CITY OF CHARLEVOIX
210 STATE ST. CHARLEVOIX, MICH. 49720
PLANNING COMMISSION PUBLIC MEETING AGENDA

SUBJECT: Continued: Site Plan Review: Midtown Development, Inc., 115 Pine River Ln. – Residential Development

Tim Burden
Proposed Residential
SITE AND DIMENSION PLAN
Sections 26 & 27, Town 34 North, Range 8 West
City of Charlevoix, Charlevoix County, Michigan

Figure 5 Enlarged Updated Utility Plan and The Lakehouse Chestnut Tree

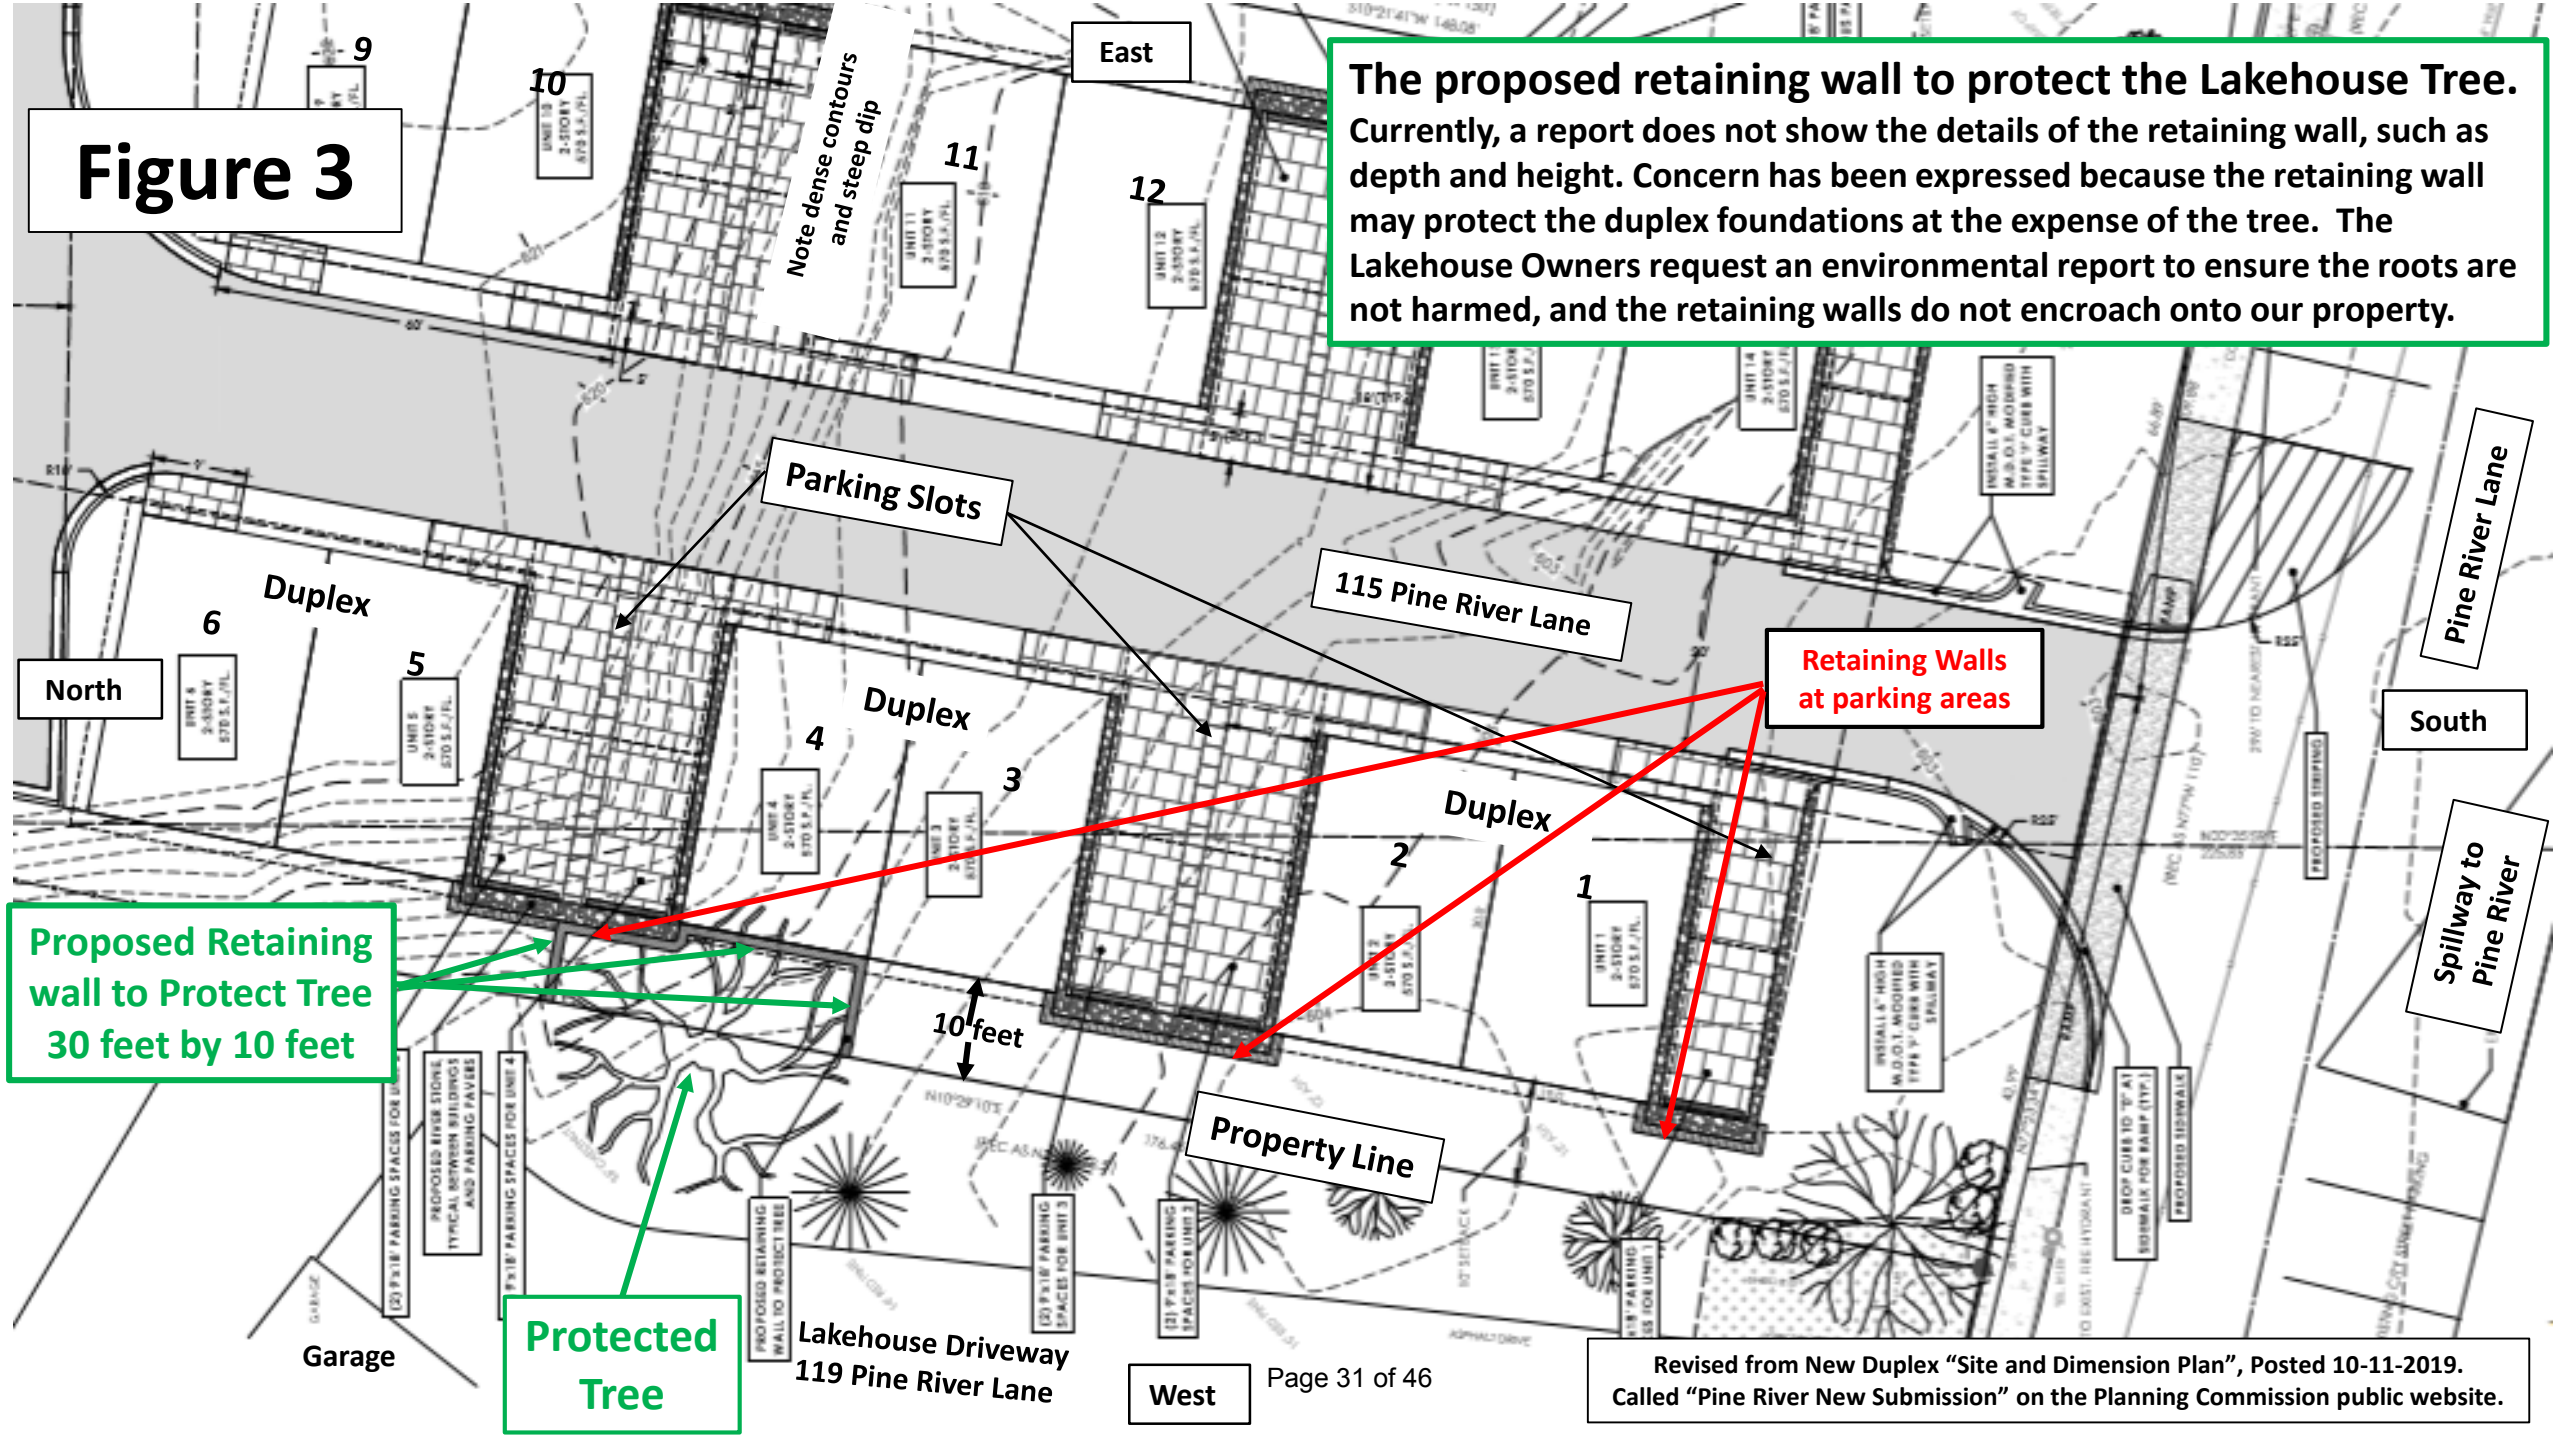
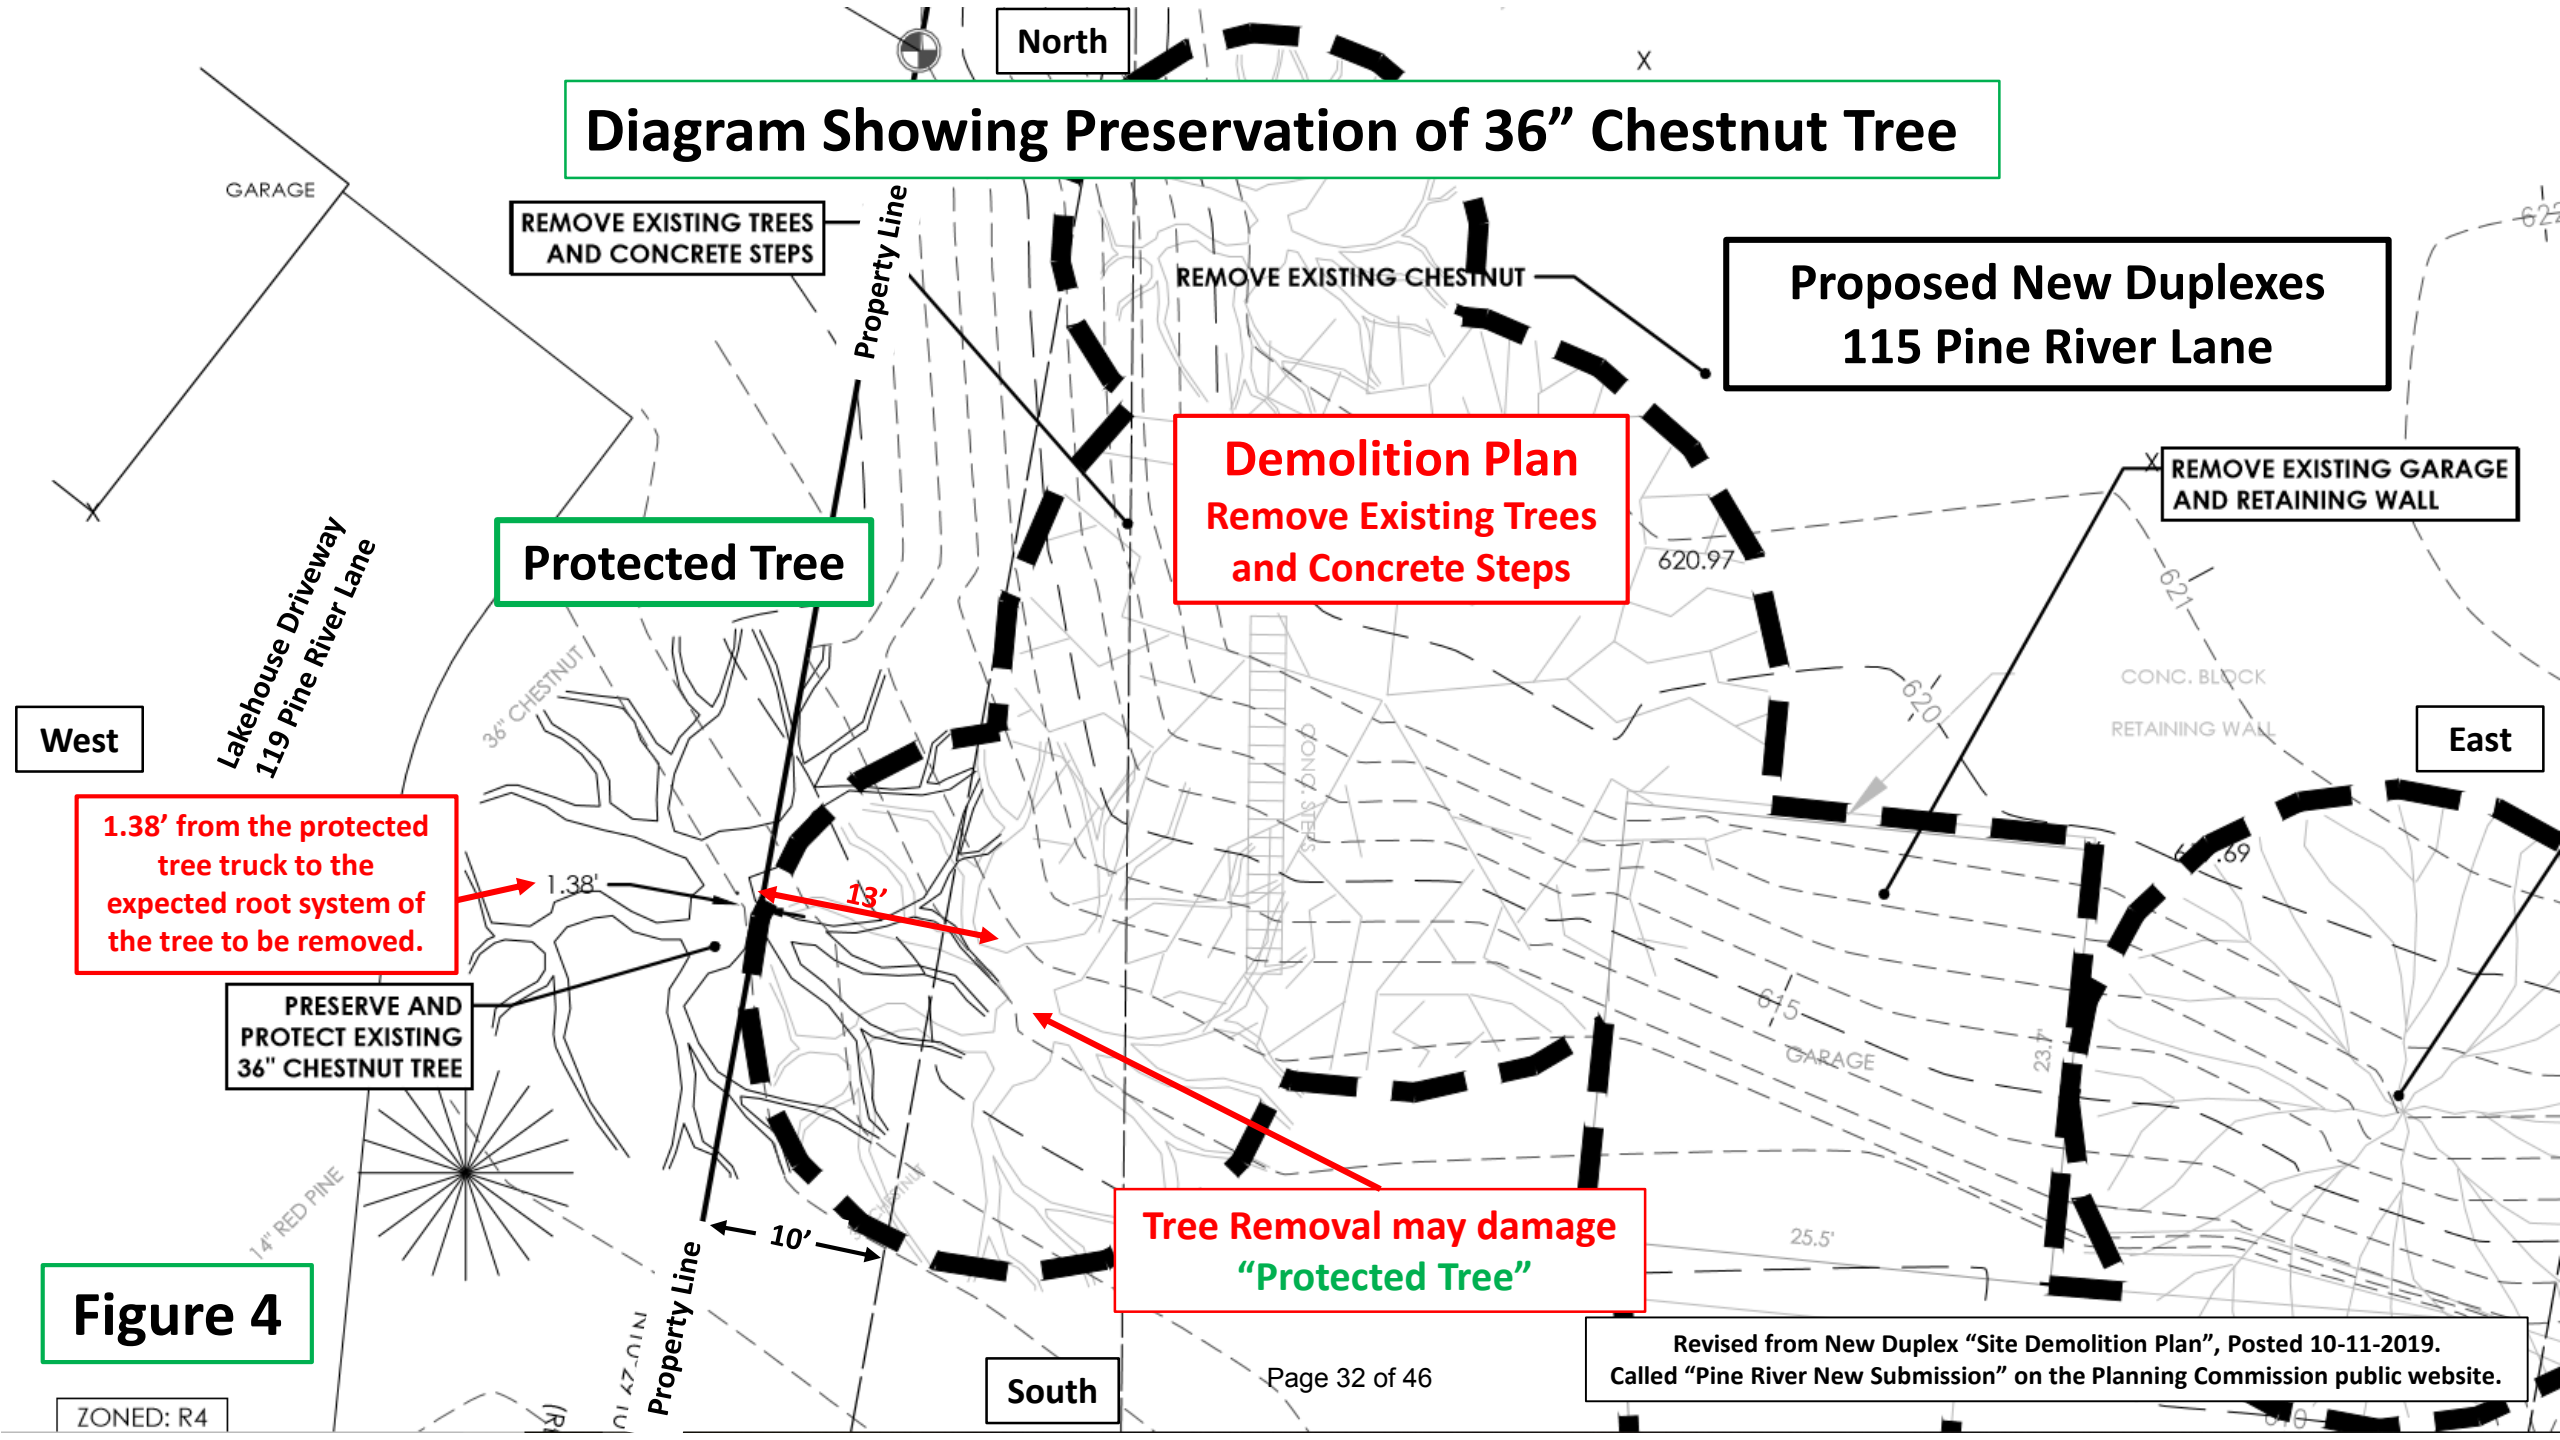
Four utility lines are proposed and two of them, gas and electricity are deep lines. The excavations will clearly damage the tree. I estimate that 30 % to 40% of the root system will be cut. 153.235 (C) states that the site must be designed to minimize hazards to adjacent property. Clearly, that does not seem to be the case here. I thought that you and the Planning Commission need to be made aware of this change (figure 5). Please do not allow further excavation that will damage our tree. Please forward this letter and three attachments to the appropriate Members of the Planning Commission and City Council. I cannot attend the meeting, but I believe the technical nature of my concerns need to be understood by all.

Yesterday, (11/5/2019) a new Utility Plan was posted on the Planning Commission website. It reveals four utility lines within the retaining wall area surrounding the Lakehouse Tree. Some of these are deep utilities like electricity and gas. The excavations could easily cut 30% to 40% of its root structure. This could be a potentially fatal threat to this tree. Figure 5 is an enlargement of the new Utility Plan that shows the utility lines cutting through the retaining wall area by the Chestnut tree.
